## **Addendum Number Two**

To The Drawings and Specifications for  
Sedgwick County **Fire Station 31**

Issue date: April 23, 2020

You are hereby instructed to include in your bids the following changes and/or corrections to the Drawings and Specifications for the **Sedgwick County Fire Station 31**, in Andale, Kansas.

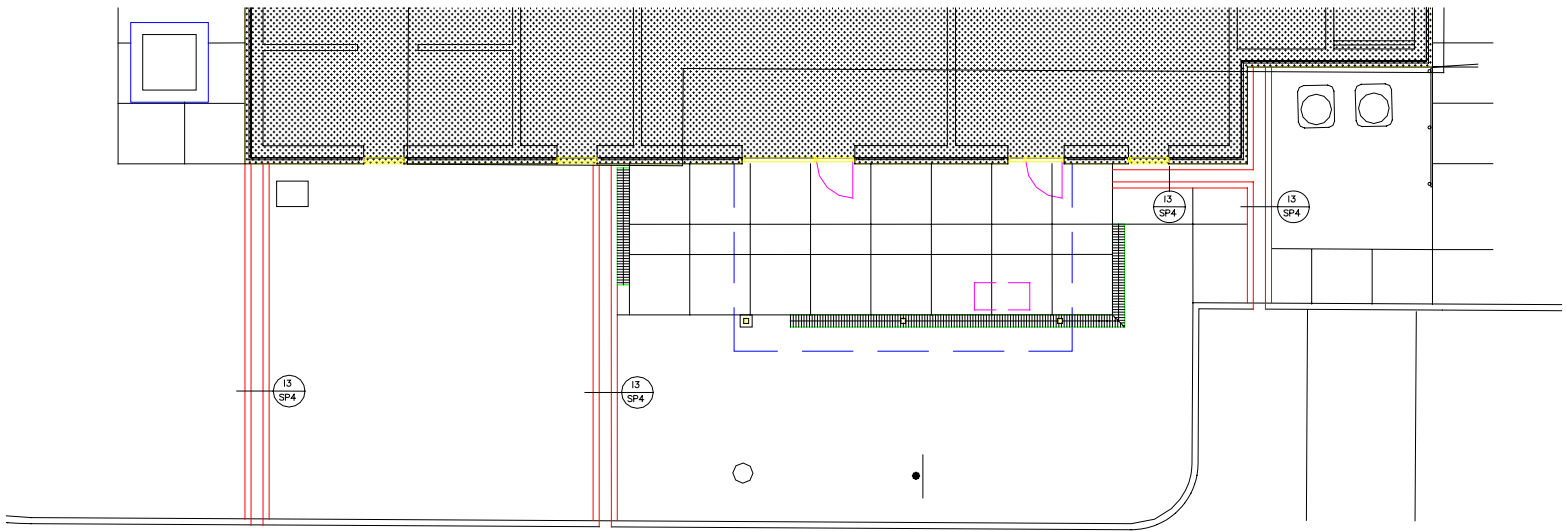
The red lines are to clarify the extent of curbing on the North side of the South drive. A portion of this curb is shown on C1.0 and none is shown on SP-1. This curbing shall be added by this addendum.

The red lines are to clarify the extent of flumes on the South side of the Fire Station.

# 30022 T6X

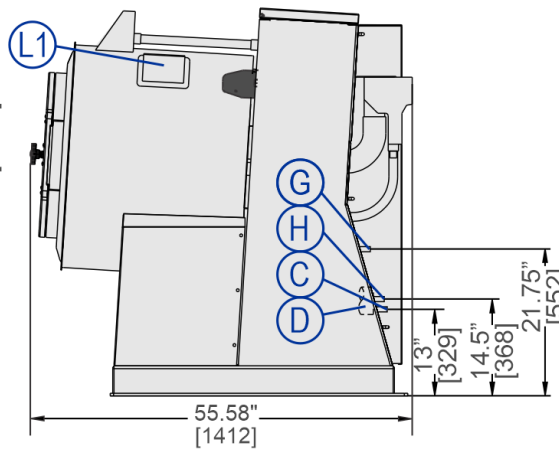
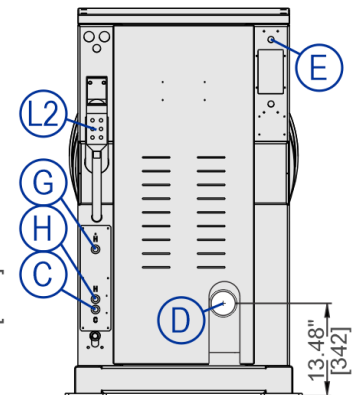
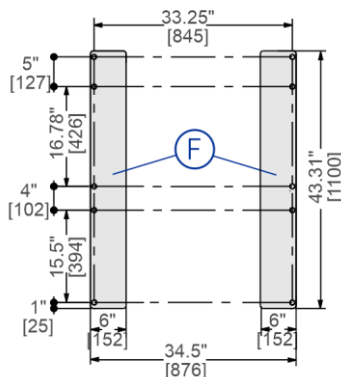
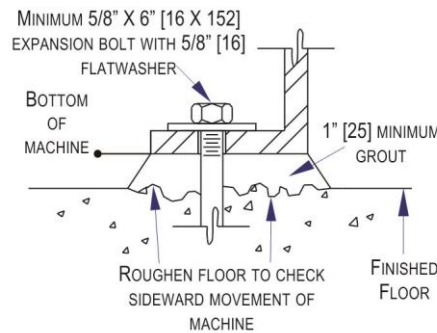
- 1.11 Extractor (Milnor)
- A. The extractor is a large washing machine that is provided by the Owner and Installed by the General Contractor. The unit is manufactured by Pellerin Milnor, Model 30022T6X. <https://www.milnor.com/products/30022t6x/>

- B. The Plumbing contractor shall provide hot and cold water connections as noted in the Fixture Schedule on P1.1 – P17 - Extractor.
  - C. The Electrical Contractor shall provide power as noted on Sheet E3.1, note 39.

S5.1

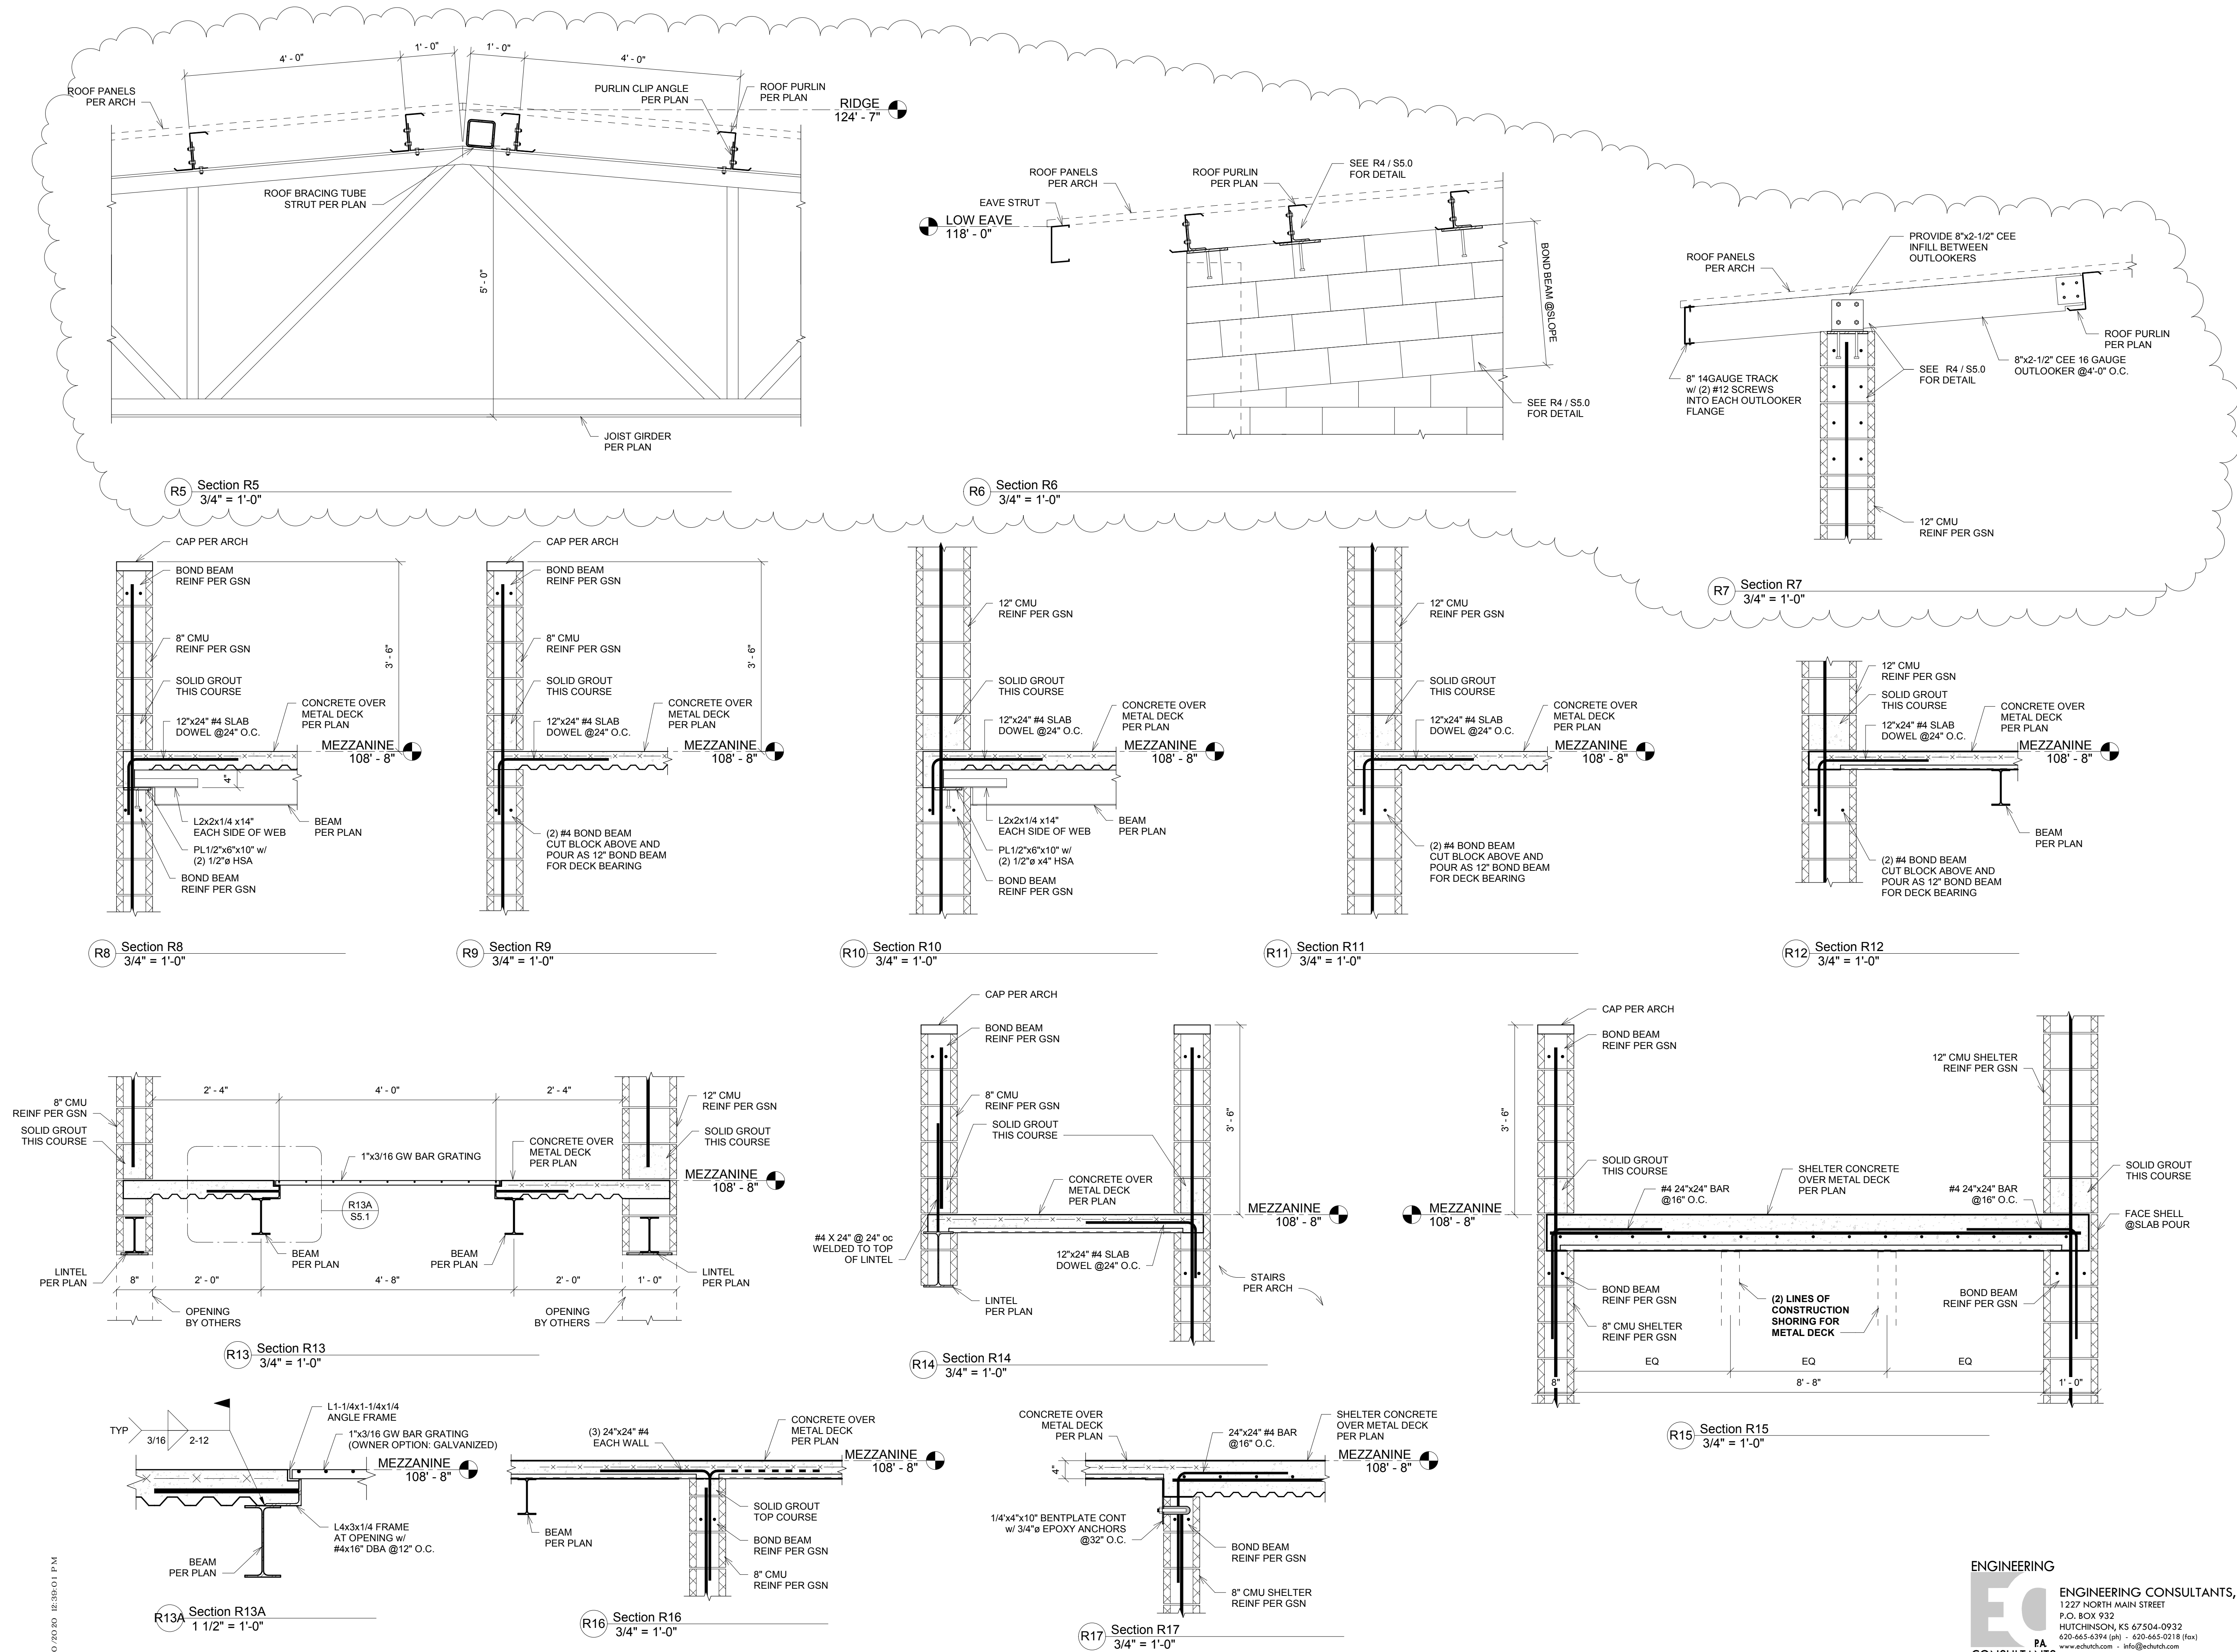
- B. Sections R6 and R7 have been added to the revised S5.1.
  - C. Section R13A, the Bar Grating shall be galvanized.
- 3.22 Sheet S5.2
- A. This sheet has been revised and is reissued with this addendum.

SHEET  
C3.0  
OF 1 SHEETS

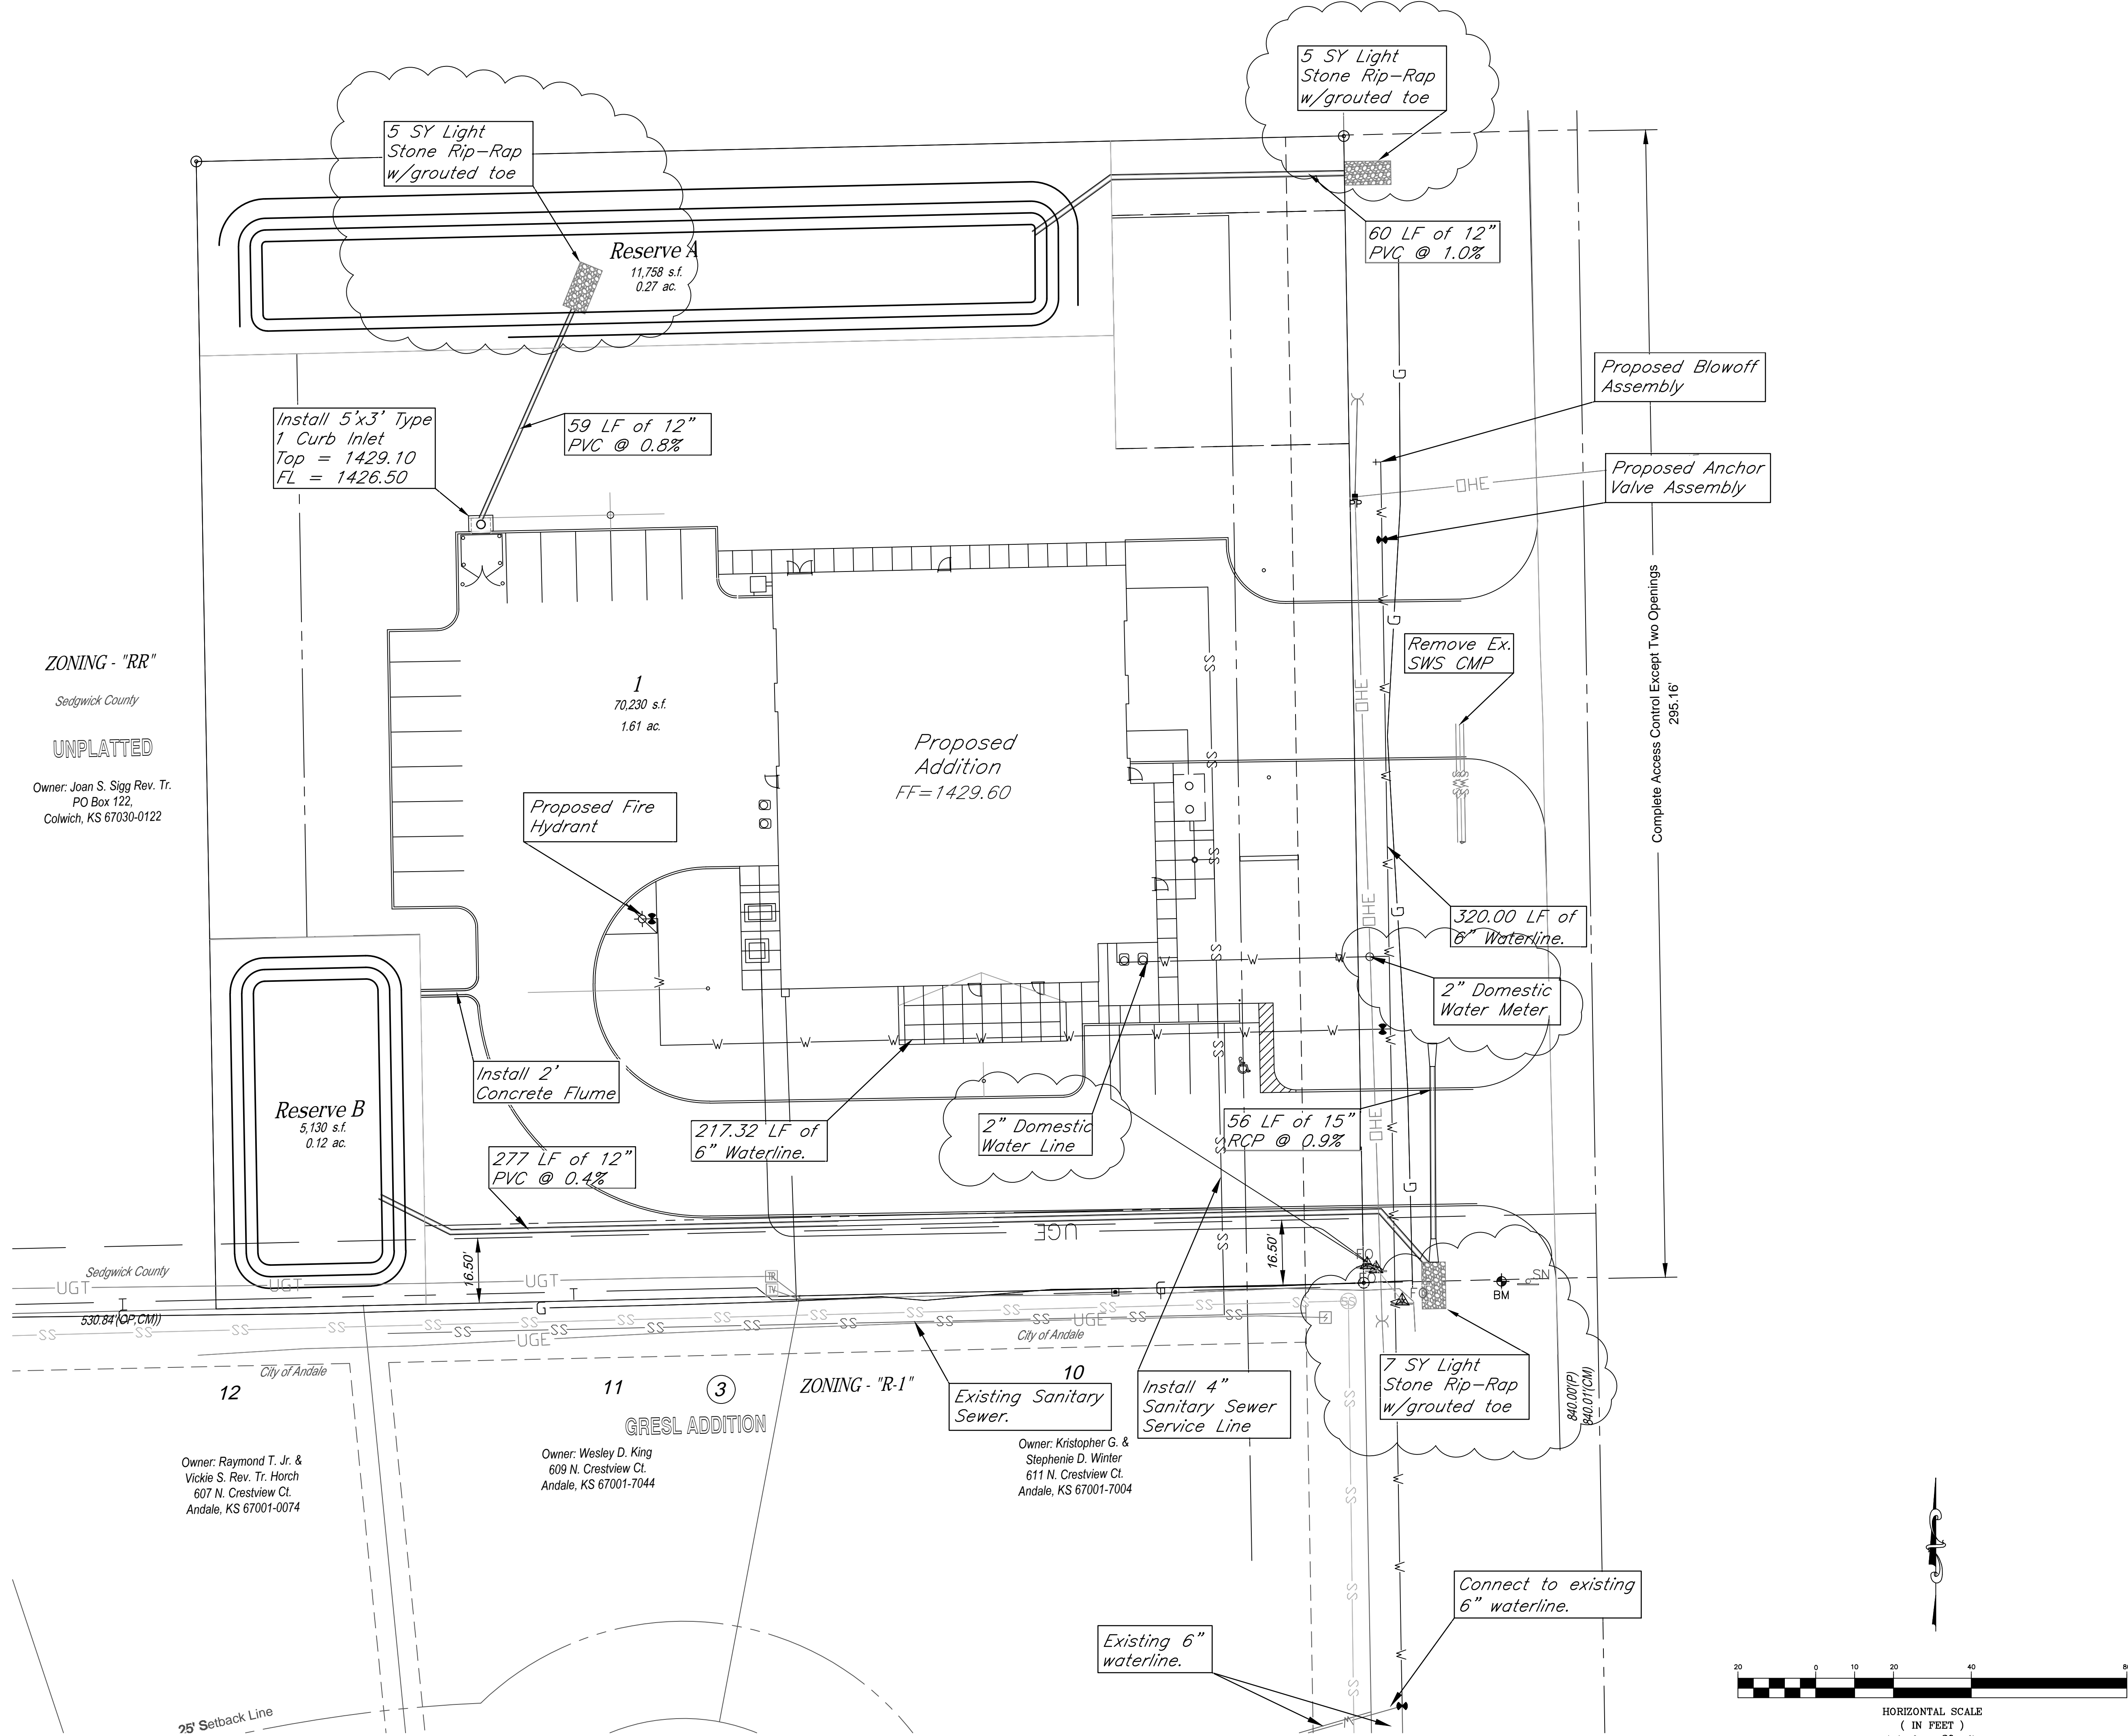
- A. A revised Sheet C3.0 is issued with this addendum.
- B. The size of the water service shall be changed from 1" to 2". The water service shall be schedule 40 PVC.
- C. The size of the domestic water meter shall be changed from 1" to 2".
- D. Storm Sewer
  - 1. Tapered pipe end sections are required on both ends of the 15" RCP.
  - 2. Grouted Toe-Walls will be required.
  - 3. The rip-rap shall be "light stone" as defined by the City of Wichita.
